TRIUMPH DISTRIBUTORS

TO: ALL DEALERS

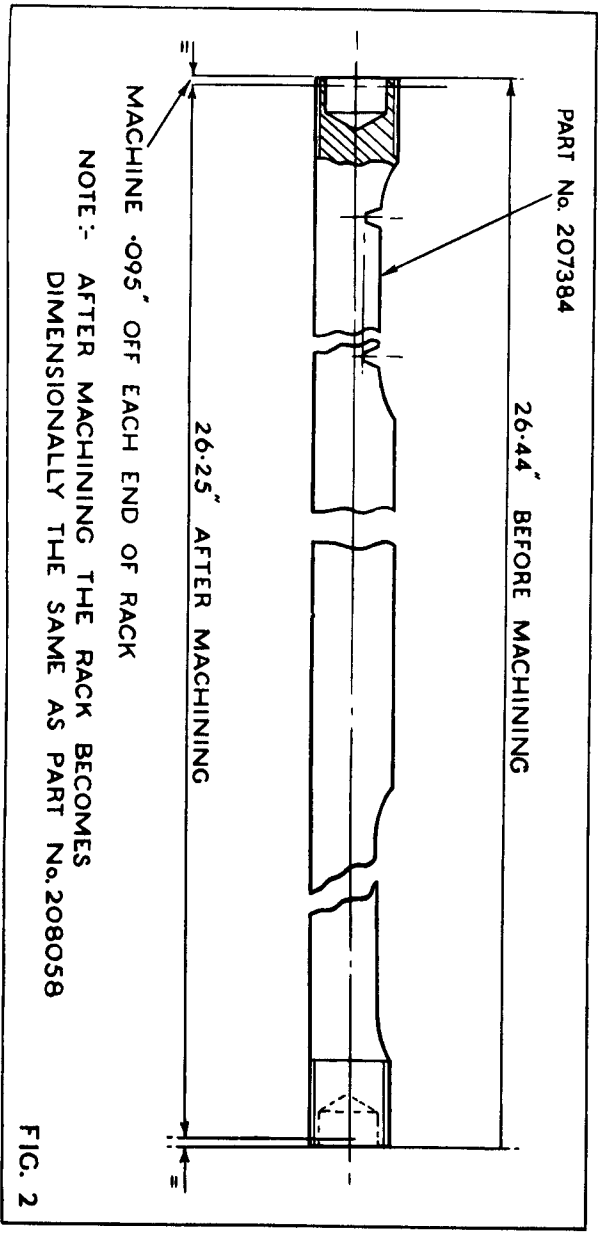
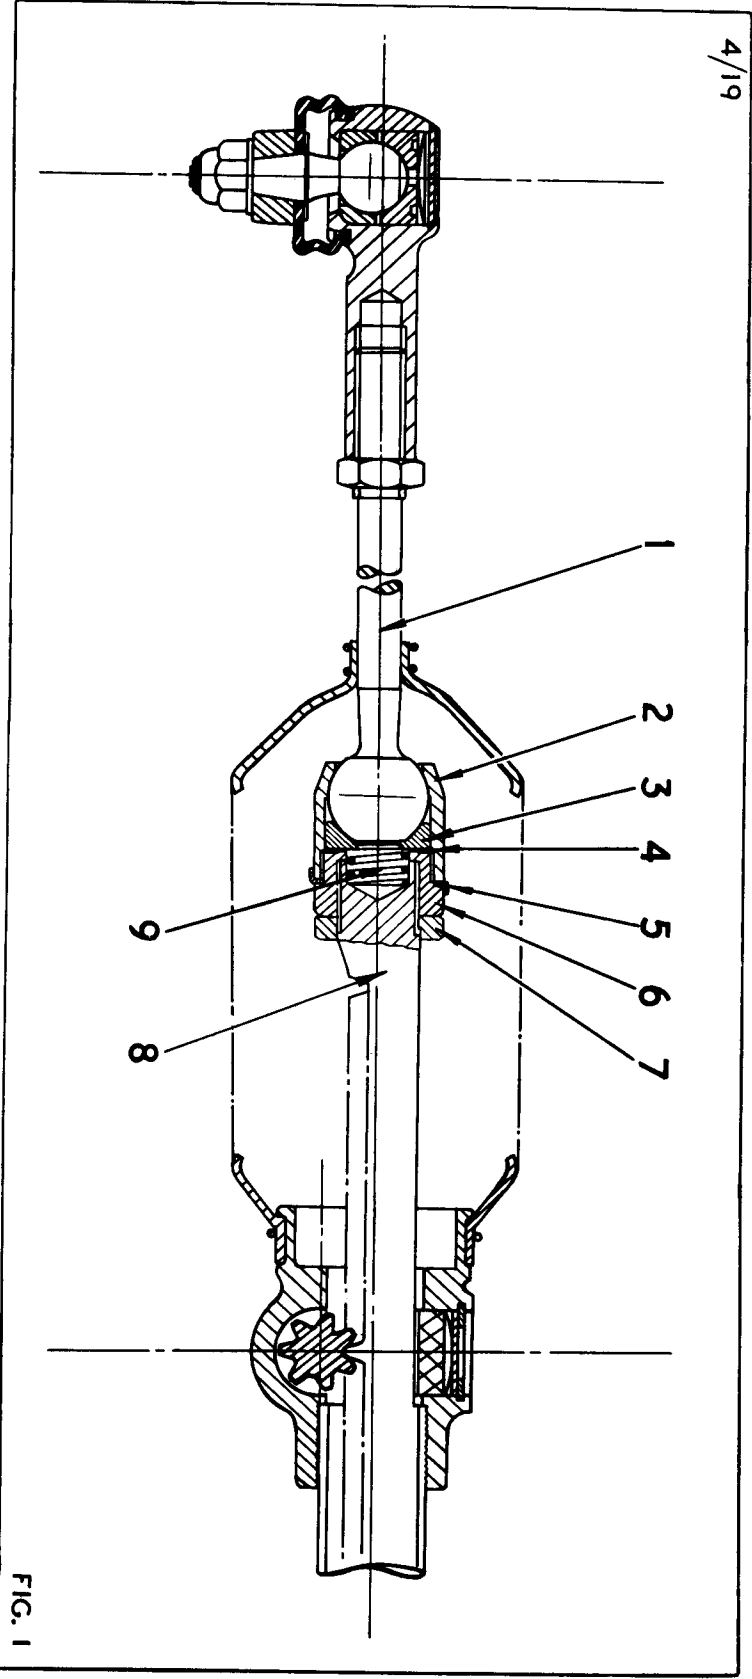
To prevent over-tightening of an inner ball joint assembly, this being the subject of Service Bulletin T-61-23, a new steering unit, incorporating shims for ball joint adjustment, has been introduced from Commission Numbers:

The redesigned inner ball joint assembly permits detachment and re-attachment of the steering tie-rod to the rack without the need for re-adjustment, provided that the existing shim pack remains intact and that wear is not excessive. Should either condition permit "ball-lift" in excess of 0.002", then re-adjustment will be necessary.

Referring to Figure 1, the servicing operations are as follows:

Early type inner ball joint assemblies cannot be fitted to the new steering unit, but the new ball joint assemblies may be fitted to the earlier type steering units, provided that the rack is modified as shown on Figure 2.

1. Release the rubber bellows and move this clear of the ball joint.
2. Slacken the locknut (7) and remove the ball joint assembly by unscrewing the sleeve nut (6) from the rack (8).
3. If necessary, dismantle the ball joint by releasing the lockplate (5) and unscrewing the sleeve nut (6) from the cup nut (2).

1. Slide the cup nut (2) over the tie-rod (1) and insert the thrust ring (3) into the cup.
2. Position the lockplate (5) over the sleeve nut (6) and screw this fully into the cup nut.

3. With the cup nut held in a vice, pull and push the tie-rod to estimate the approximate amount of "ball-lift".
4. Prepare a shim pack (4) slightly thicker than the estimated "ball-lift" and insert this between the thrust ring (3) and the sleeve nut (6).
5. Add or remove shims to obtain the requisite .002" ball-lift when the sleeve nut is firmly screwed into the cup nut.

The ball should now move freely in the joint. If tightness occurs at any point, increase the shim thickness sufficiently to overcome this.

<u>Part Number</u>		<u>Part Number</u>
304689	- Rack and Pinion Assembly R.H. replaced by	305050
304690	- Rack and Pinion Assembly L.H. replaced by	305051
207384	- Steering Rack replaced by	208058
120954	- Adaptor replaced by	129963

- 129961 - Inner Ball Joint Assembly
- 130031 - Shim 0.002" thickness
- 130032 - Shim 0.010" thickness

FIG. 1

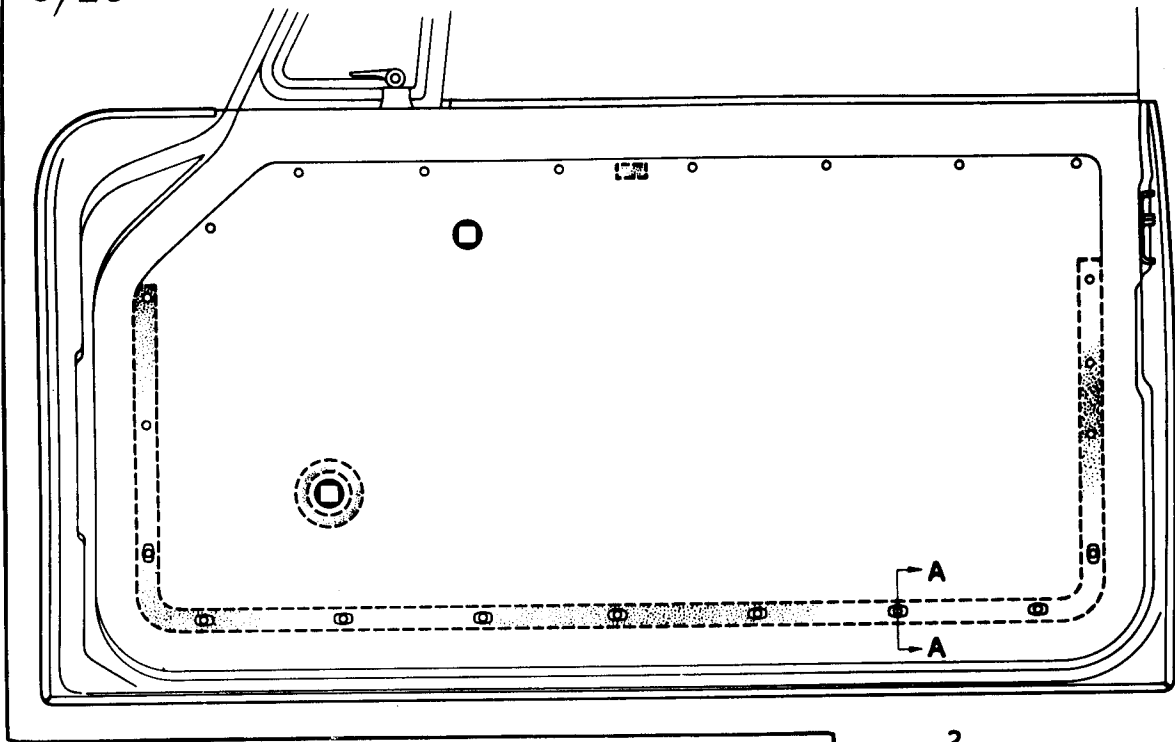
The plastic screen which is fitted to the operating channel at the lower edge of the glass on early models has been deleted from the specification. This has been replaced by a smaller plastic screen which is fitted to protect the locking mechanism. The door inner panel is now completely blanked off with a "Weather Curtain" which is sealed around the interior handles and lower edge of the door with Glasticord 400 sealing compound.

Apply a continuous strip of sealing compound to the lower and side edges of the curtain. This is shown as a dotted line in Figure 1. The sealing compound must not be stretched or overlapped as it is being applied.

FIG. 2

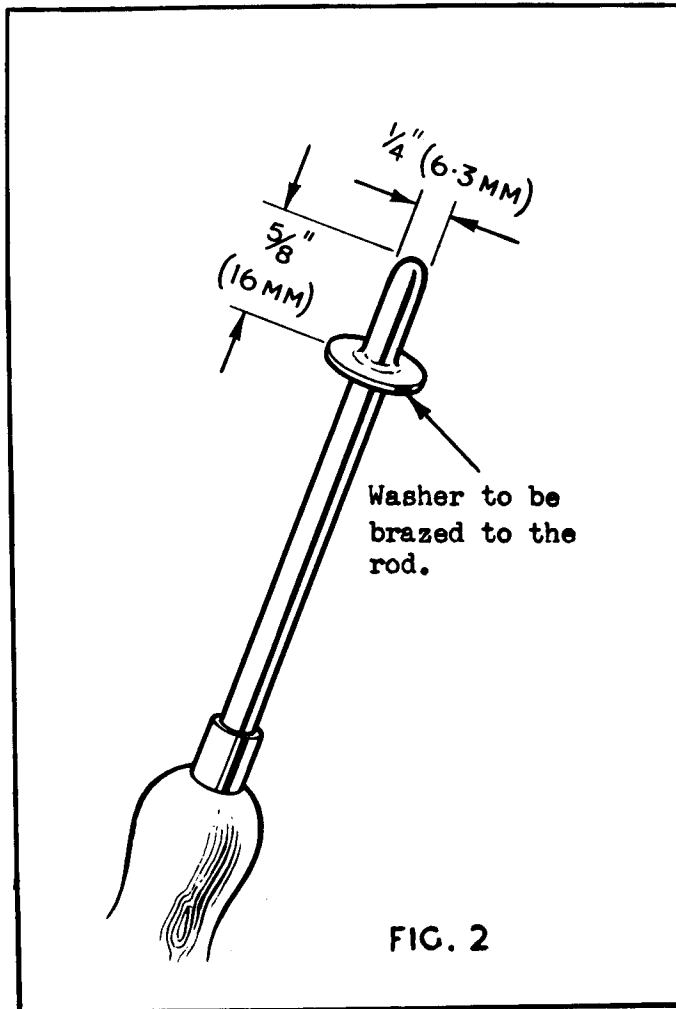
Press the "Snapsacs" into position by using the easily made tool shown in Figure 2. "Snapsacs" are easily damaged and should be renewed as necessary.

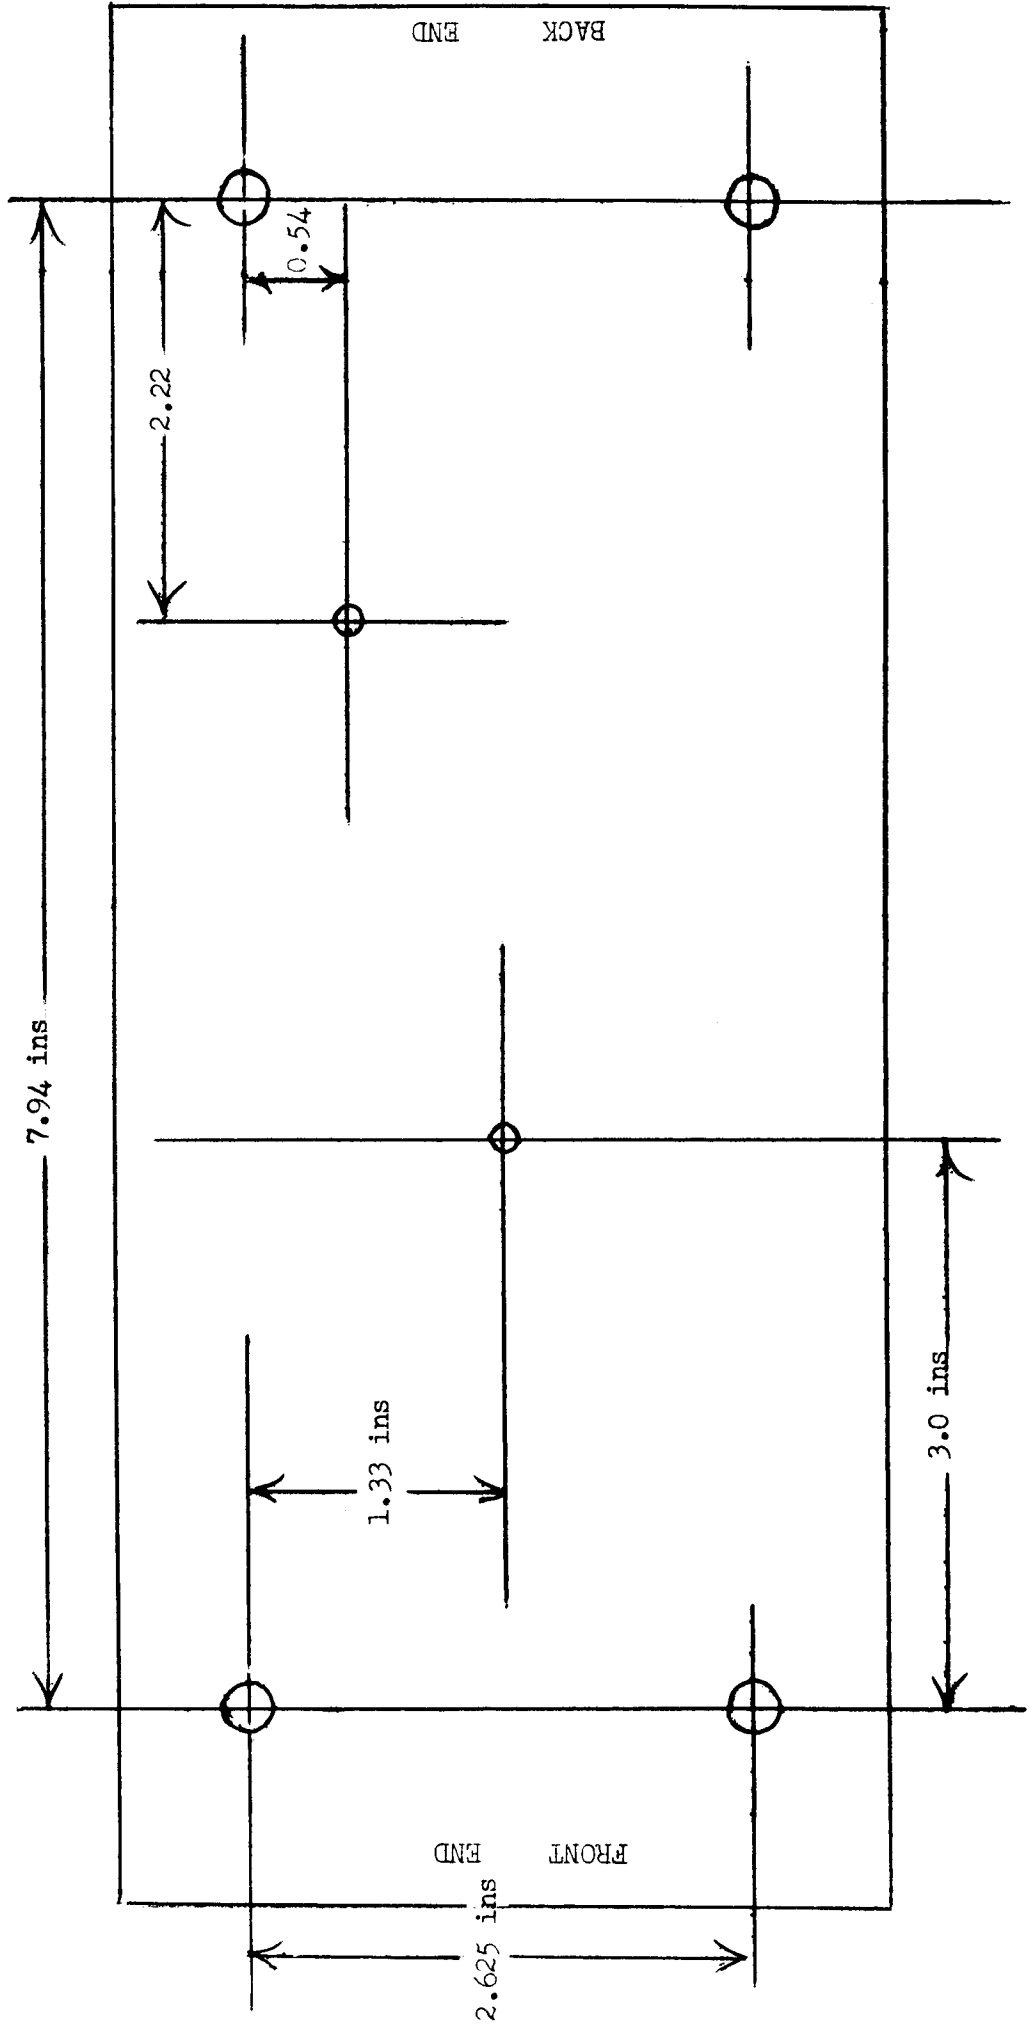
On earlier cars, the holes for the two switches will be found already drilled, and no difficulty should be experienced in removing the plugs and inserting the switches. However, on current models, these holes have not been drilled and a template can easily be made to facilitate the positioning which is not necessarily in the center of the boss on the casting.

The template, shown on the attached sheet, can be made from thin metal plate, and is located on the gearbox top extension with the four holes corresponding to the attachment stud holes. Center punching through the small holes in the template will then enable the drilling position for the isolator switches to be obtained.

The dia gram shows the top view of the template. The four locating holes to be drilled 11/32" and the two smaller holes approximately 1/8".

The switch holes can be drilled and tapped, using a 17/32" drill and a 16 mm x 2 mm tap. It will be necessary, however, to remove the selector rods, etc., from the extension, prior to drilling, in order to avoid damage and to enable the resulting metal particles to be thoroughly cleaned away.

FIG. 2

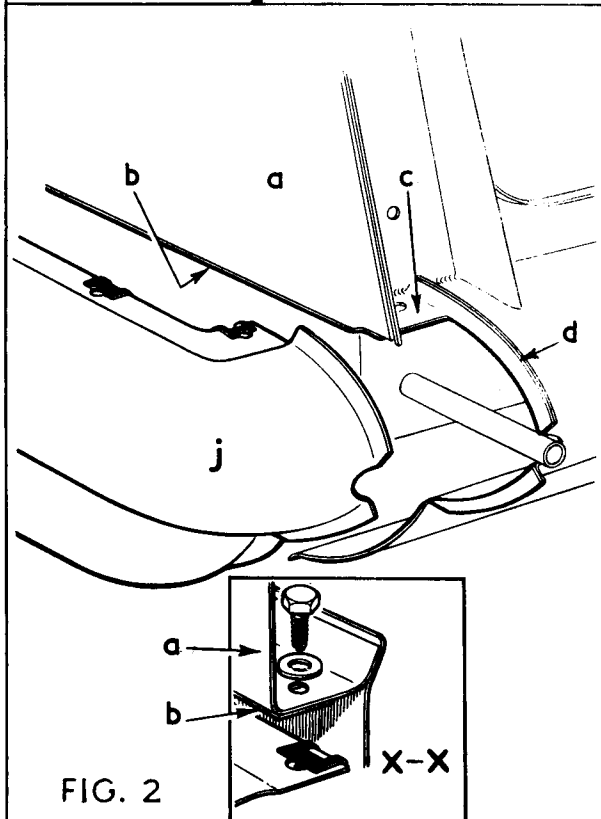
Cut the damaged valance at (b), flush with the tonneau side panel (a) as shown in Fig. 2. Cut the outer edge of the rear flange at (d), and across the tail lamp aperture (c) .93" (24mm.) from the forward edges of the aperture.

FIG. 3

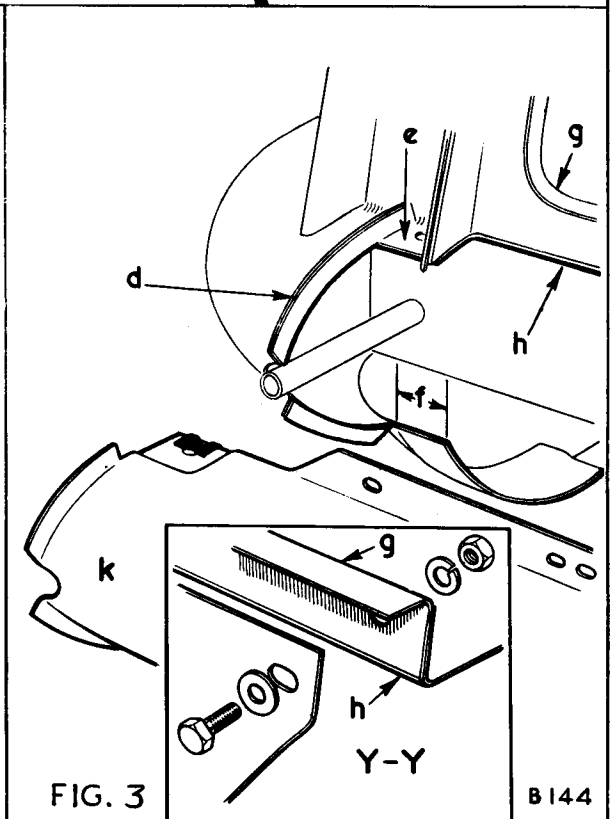
Cut off the old valance at (h), flush with the lower edge of the locker flange (g) as shown in Fig. 3 X-Y, cut the inner edge of the rear flange (d) and across the tail lamp aperture (e) $.93"$ (24 mm.) from the forward edge of the aperture.

EXISTING ASSEMBLY.

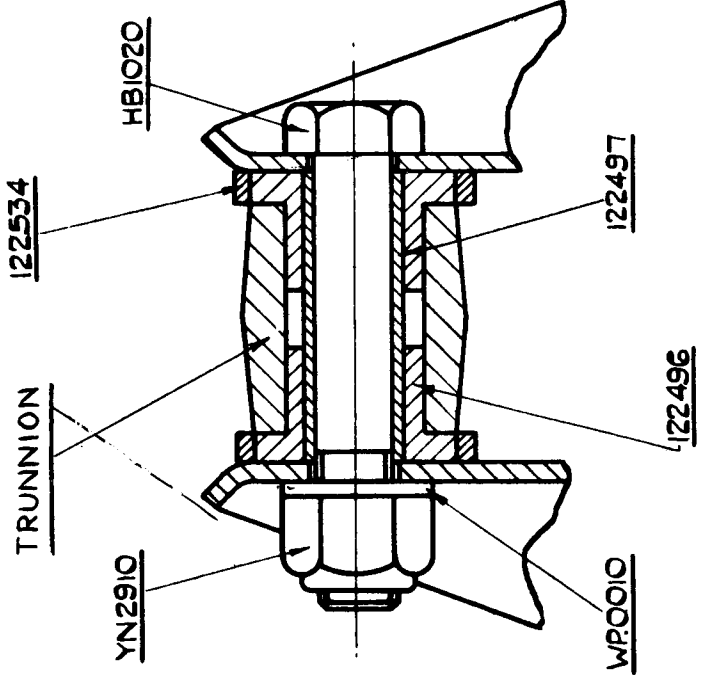
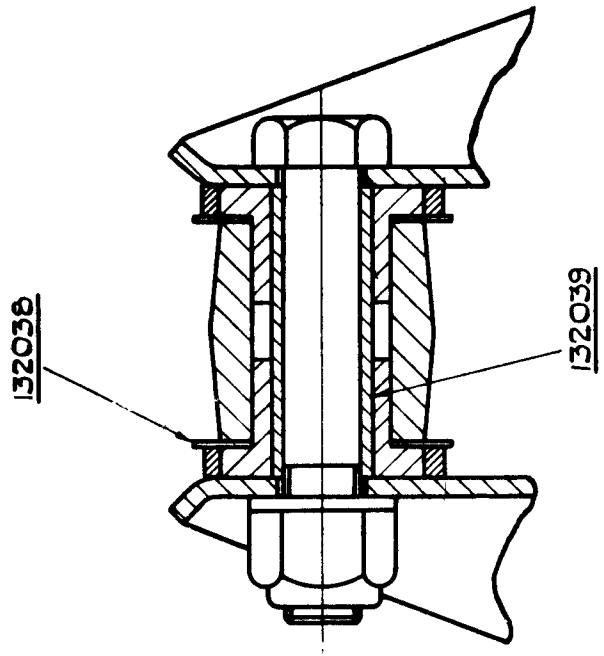
To improve the sealing and prevent premature wear of the bushes of the front suspension lower trunnion, shims have been added to the assembly as shown in the illustration.

When the occasion arises to renew the trunnion bushes, these shims should be added, which necessitate replacement of the distance piece Part No. 132039, in place of the original distance piece Part No. 122497. The fitting instructions are as follows:

1. Remove hex. nut YN 2910 and washer WP 0010. Withdraw hex. bolt HB 1020.
2. Remove distance piece 122497, bearing 122496 and seals 122534 from lower trunnions.
3. Reassemble above items as follows:
Fit shims 132038 between bearings 122496 and lower trunnions as shown in modified assy.
4. Fit distance piece 132039 in place of 122497. Fit seals 122534.
5. Reassemble and insert hex. bolt HB 1020.
6. Replace washer WP 0010 and hex. nut YN 2910.

INNER AXLE SHAFT
(MODIFIED CIRCLIP GROOVE)

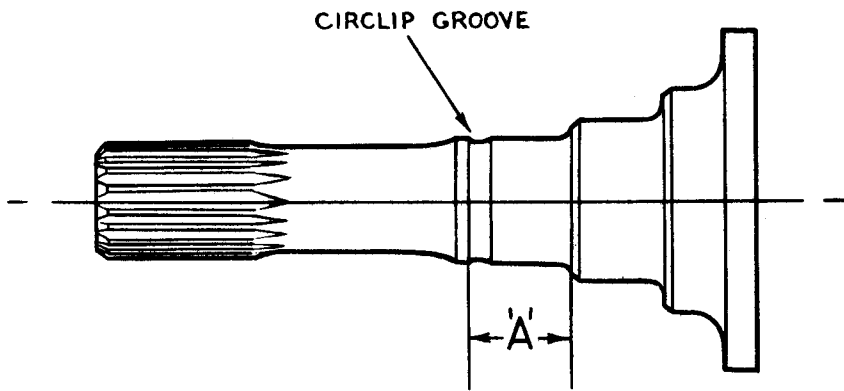
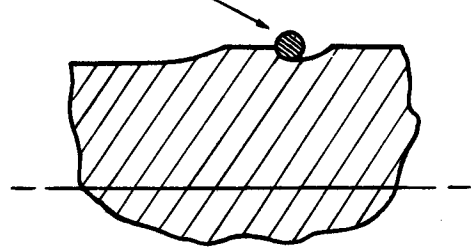
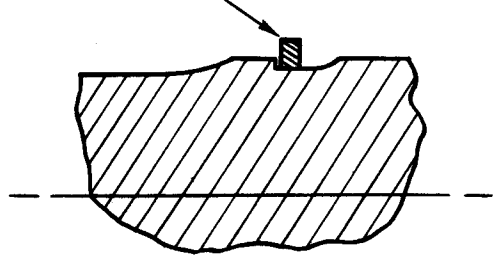
Inner half shaft assemblies from rear axle numbers GA-35604 and Y-31501 incorporate a revised circlip groove. These shafts may be used to replace the earlier type, provided that the revised circlip is also fitted and the existing thrust washer discarded.

The illustrations will assist in the identification of both the new and old type shafts.

PART No. 132649 - DIM. $\overset{A}{\text{A}}$ 0.643"/0.648" (16.33/16.46mm)
PART No. 117661 - DIM. $\overset{A}{\text{A}}$ 0.683"/0.685" (17.35/17.40mm.)

<u>Item</u>	<u>Existing Part Nos.</u>	<u>Replaced by Part Number</u>
Inner axle shaft assembly	117661	132649
Circlip	121680	132650
Thrust washer	120327 (No longer required)
